Consultation submissions

Officer Response to Key Themes

Image 1:

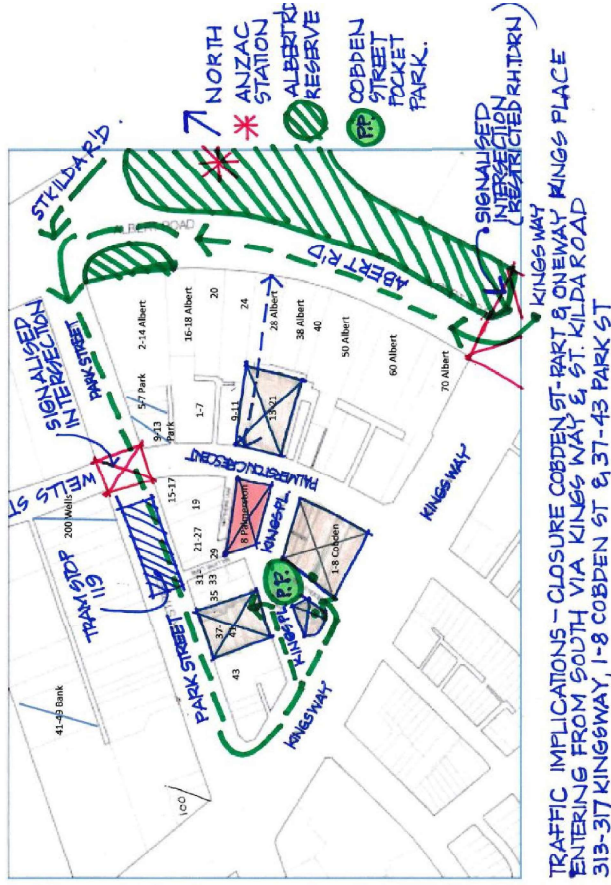
<p>2.1 It is unclear in the documents provided as to how cyclists are proposed to safely travel on the modified road network to the Pocket Park or thru it to connect to the proposed Park Street Bike path, Anzac Station / Albert Road and St Kilda Road bike paths.</p> <p>2.2 It is not clear as to where any on-street bicycle hoops are proposed to be in the vicinity of the Cobden St Parklet area. This is an important consideration given the proposed thru block connection to Anzac Station and nearby Park Street bike path linking east west and serving as a gateway to this area. These hoops should be incorporated in areas where there are outdoor dining opportunities and adjacent to the proposed Parklet.</p> <p><i>I submit:</i></p> <p>2.3 A specific detailed cycle plan is required for this area indicating all connections to key bike paths (St Kilda Road, Albert Road and Park St) which also shows hoop locations to footpaths and the proposed Parklet area.</p> <p>3.0. PARKING</p> <p>The retaining of some parking in Kings Place and Palmerston Crescent is considered necessary given the proposed reduction of on street parking in Park Street and the significant reduction of parking in Albert Road due to the building of Anzac Station.</p> <p><i>I submit:</i></p> <p>3.1 A further review of the proposed reduction in parking in the project area should be undertaken once the Minister of Planning has finalised his decision re the amendments to the Domain Precinct Development Plan being sought by CYP.</p> <p>4.0 TOWN PLANNING IMPLICATIONS</p> <p>There are discrepancies between the documents submitted for public comment and those that have been submitted to CoPP for the Town Planning approval for ADDRESS AND PLANNING PERMIT NUMBER REMOVED</p> <p>4.1 The Development proposal indicates the build on 38.6m² of current Crown land to the north-east shown on Title as 28^A which is part of the site area of this project. It is understood there is a live “adverse possession claim” by the Developer of this property currently being finalised to amalgamate this part of the site into the primary part of the site at 313-317 Kings Way.</p> <p>4.2 The Developer also proposes a reduction / removal of the northern Cobden Street footpath leading to the Pocket Park from Kings Way to establish an external loading bay for the primary use of the Development at 313-317 Kings Way as part of the closure of Cobden Street.</p>

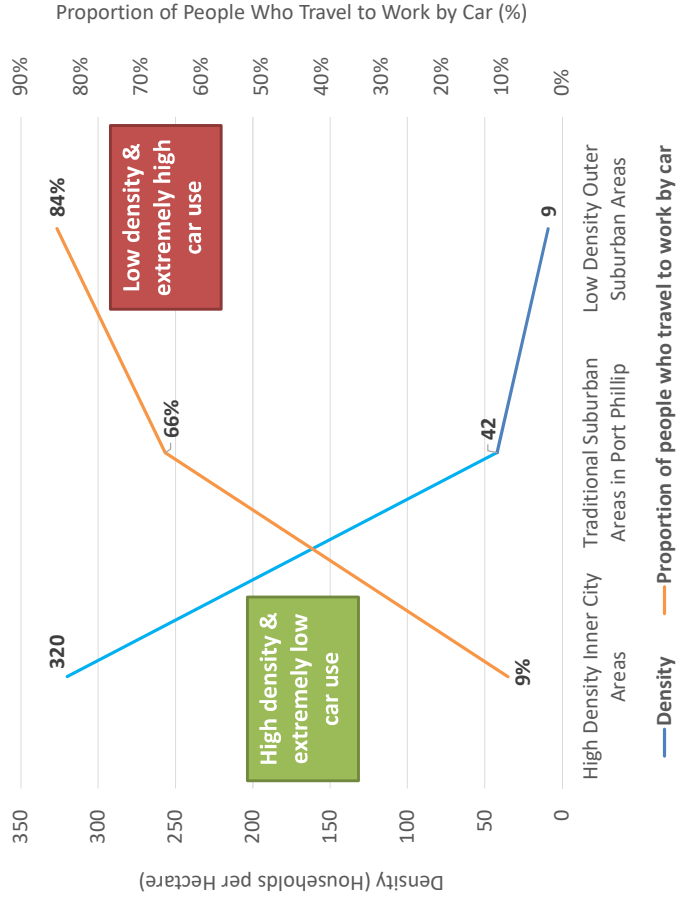
- Car use for the journey-to-work is 9% in inner-city areas with a large concentration of high density residential development. This compares to 66% in more traditionally-designed residential areas such as Elwood and 84% in low density outer suburban areas (such as Caroline Springs). This relationship is shown in the figure below. In other words, residents of Elwood drive over 7 times than residents of inner-city high-density developments. Residents in outer suburban areas drive almost 10 times more than those in inner-city high-density developments.
- Walking and bike-riding account for 37% of journey-to-work trips in inner-city high-density developments, 7% in Elwood and 0% in Caroline Springs.
